MONITORING REPORT (MY4)

ALLIANCE HEADWATERS MITIGATION SITE

Response to Monitoring Year 4 (2023) DMS Comments

Alliance Headwaters Stream and Wetland Mitigation Site (DMS #97086)
Neuse River Basin 03020201, Johnston County
Contract No. 6832

Figures 2 & 2A-2B. Current Conditions Plan View
Tables 5A-5H. Visual Stream Morphology Stability Assessment
Table 6. Vegetation Condition Assessment

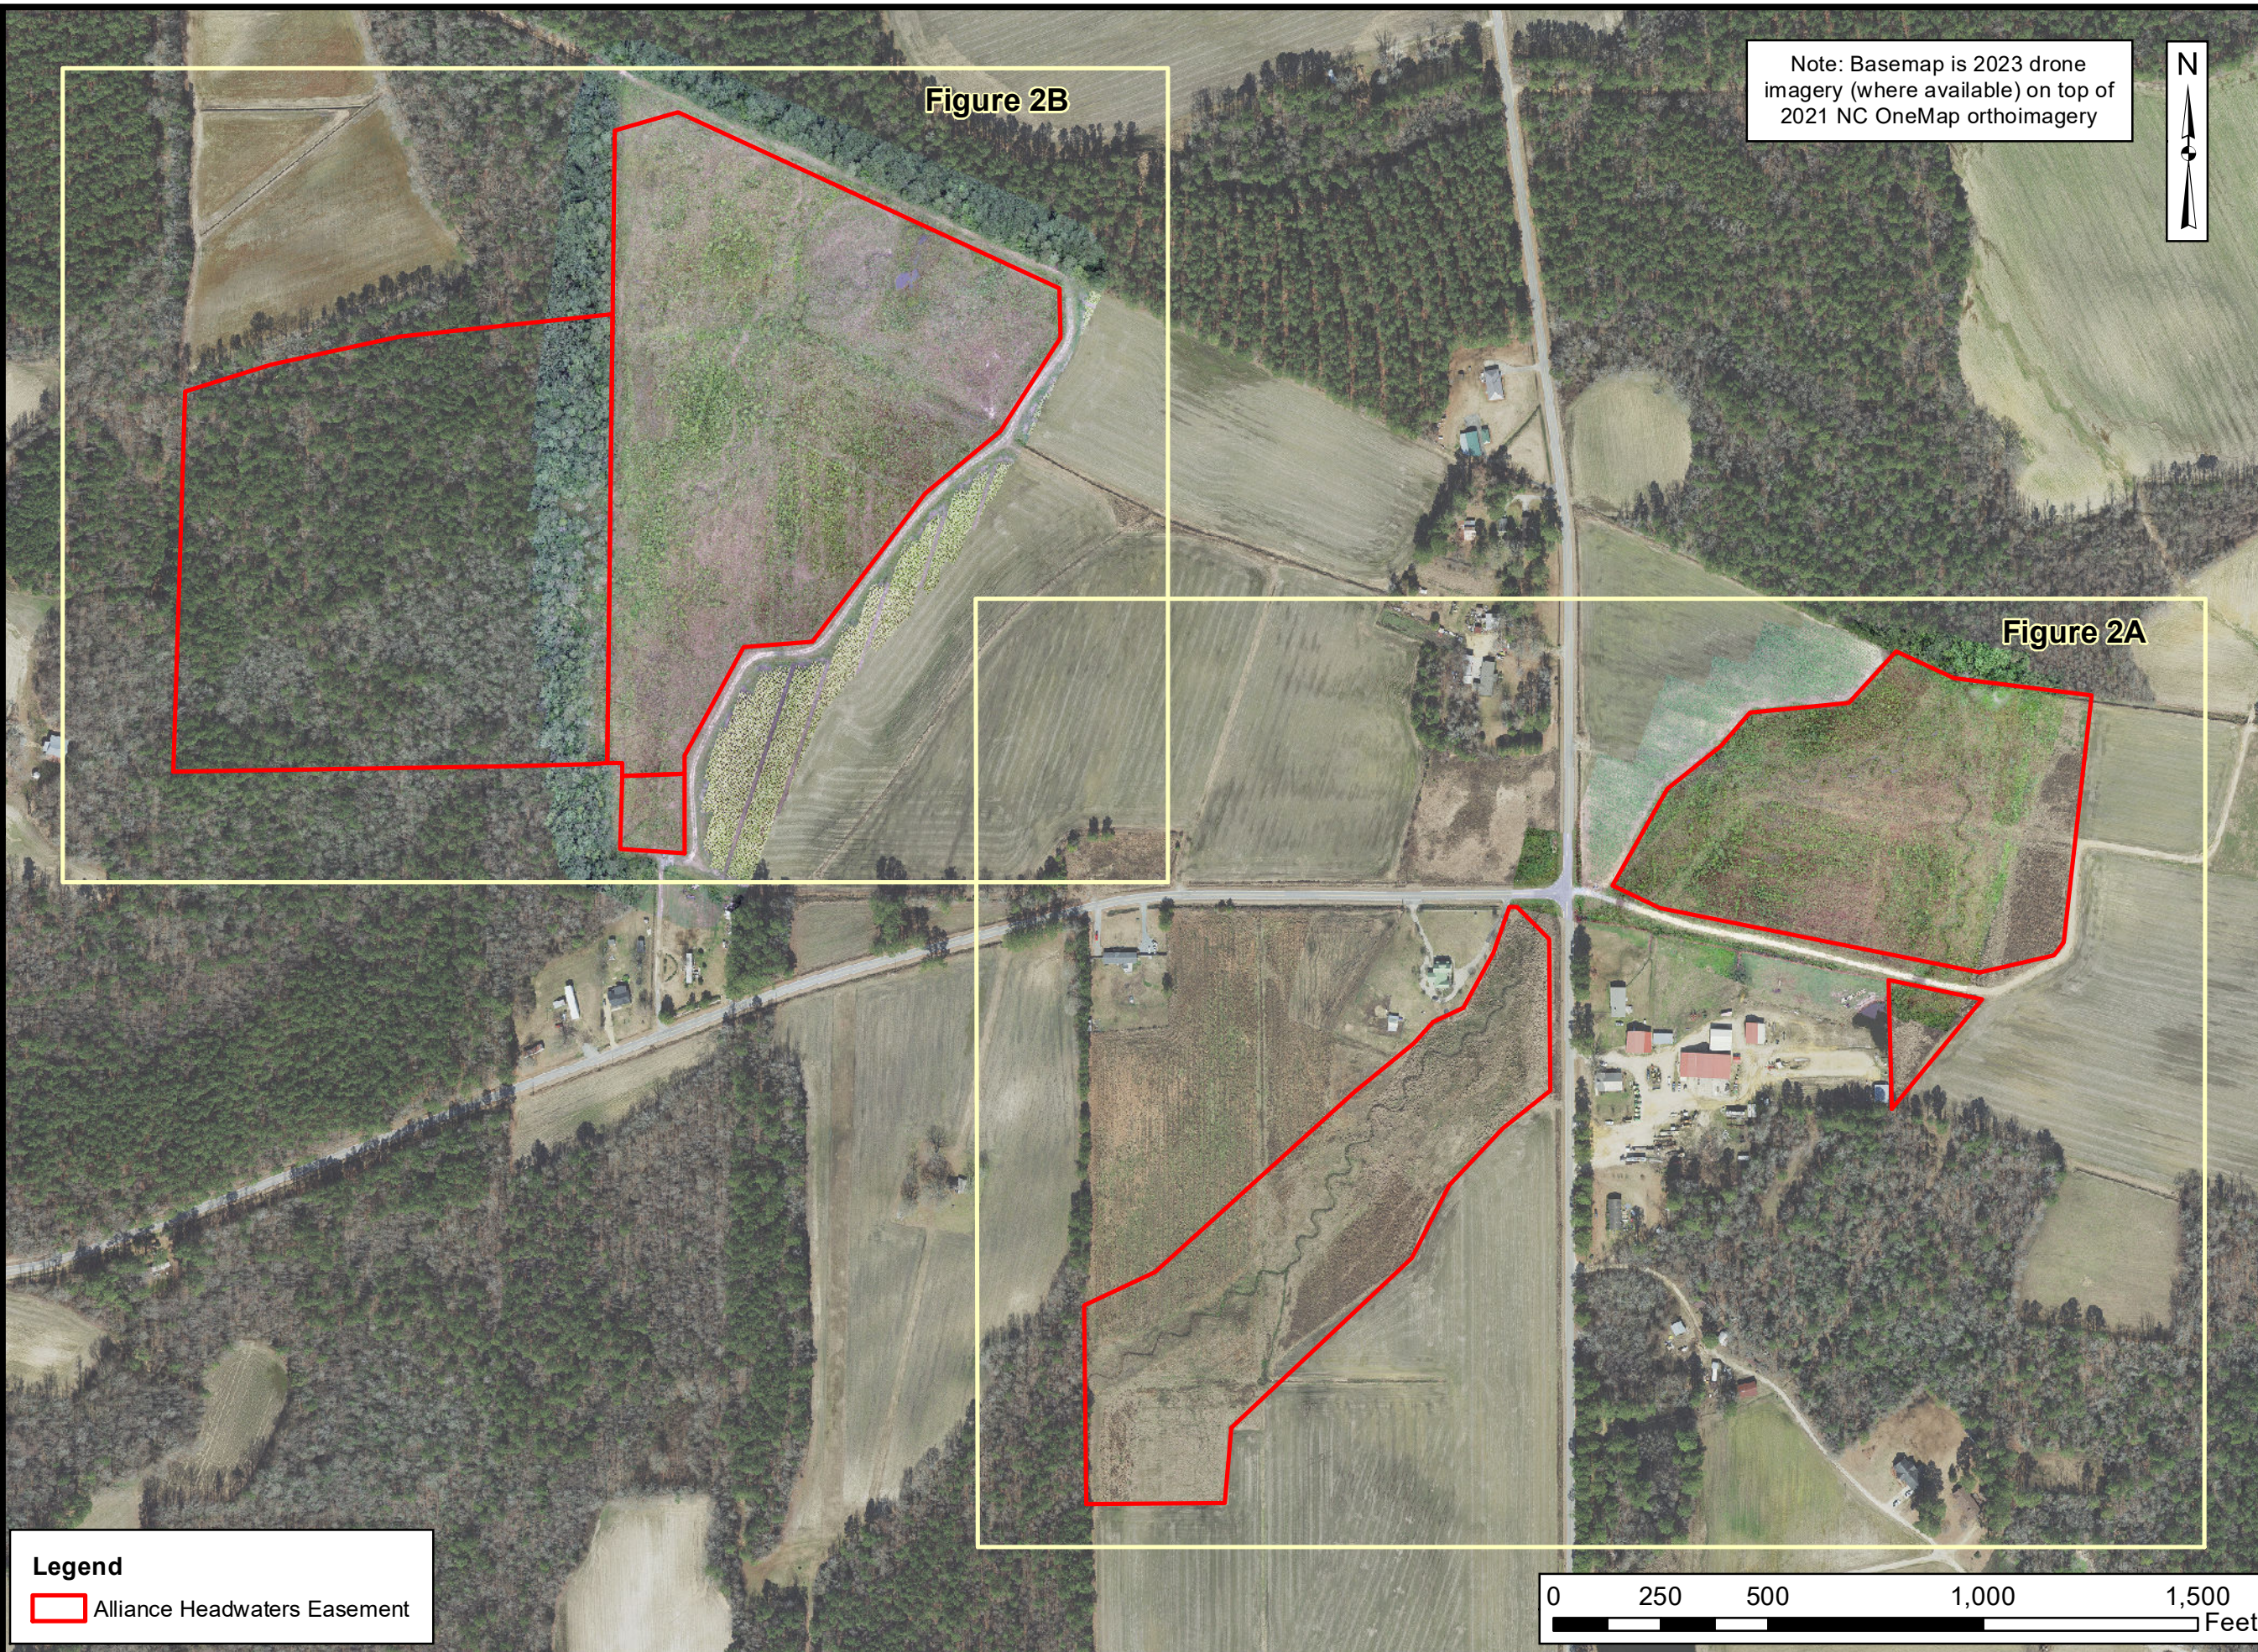
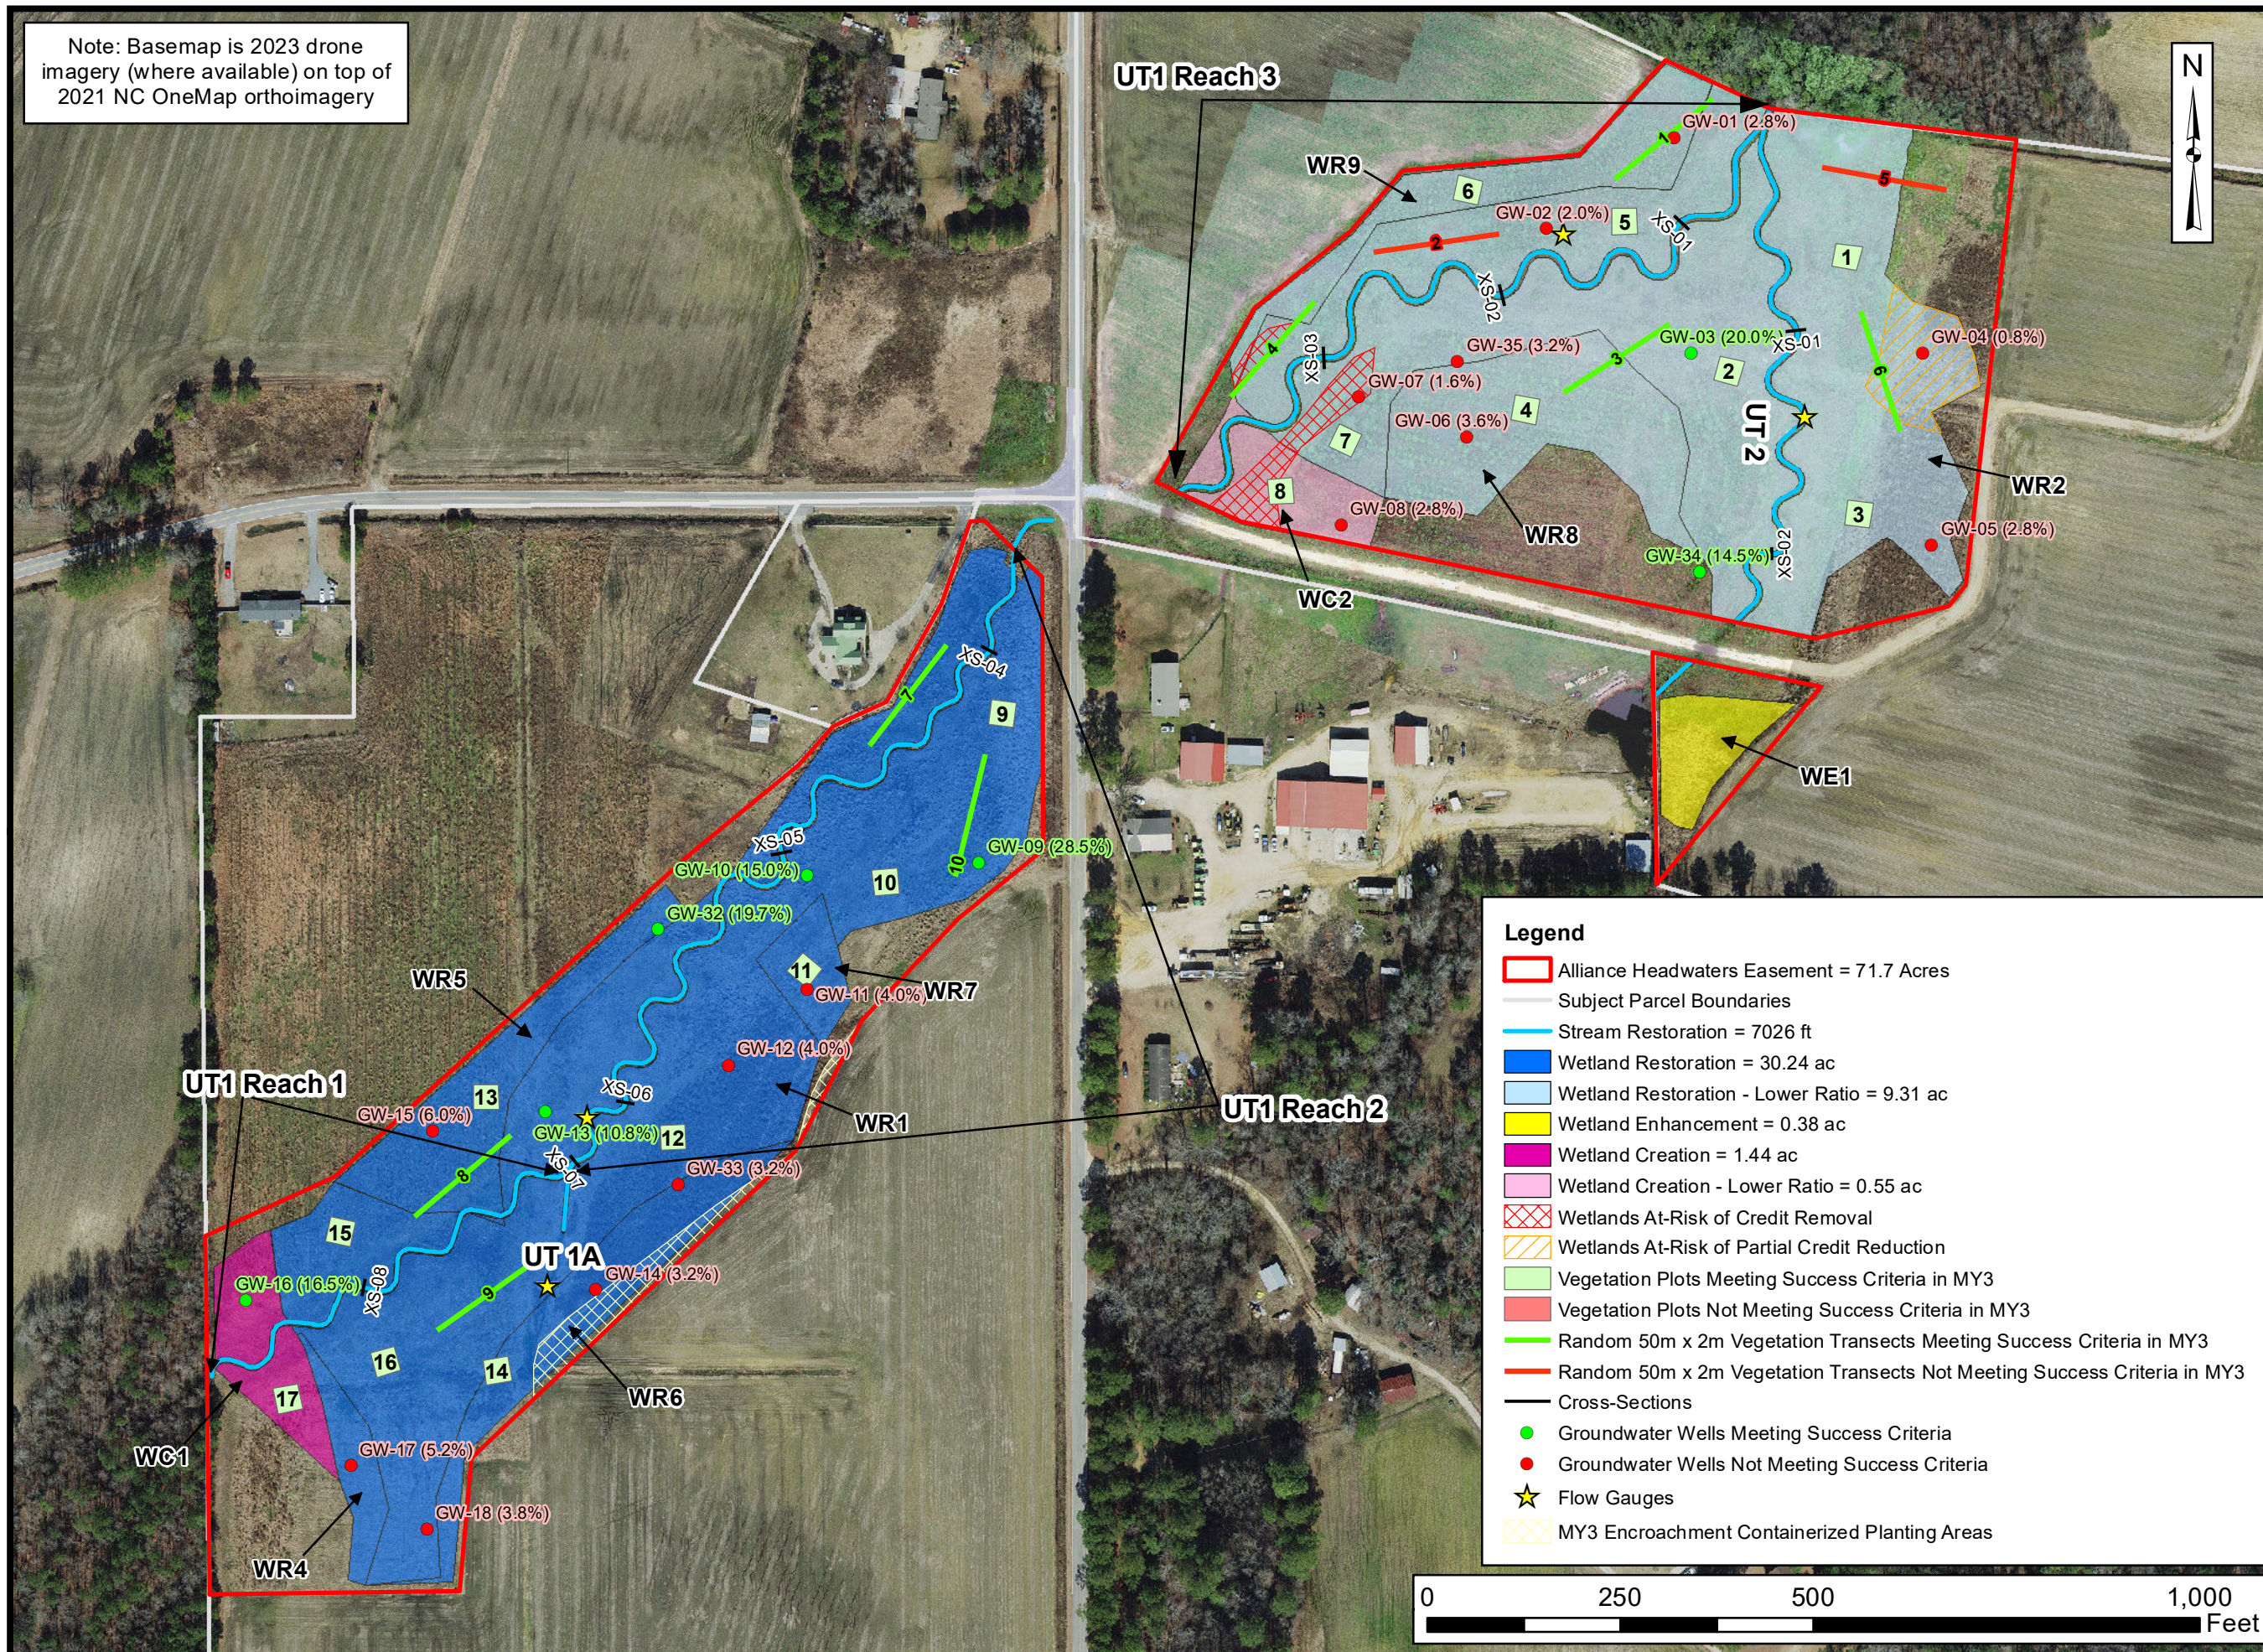
2. CCPV – Please map the at-risk wetlands.
Response: The wetlands at risk referenced in the response to comment 1 have been symbolized on the CCPV.
3. Table 11. Verification of Bankfull Events –
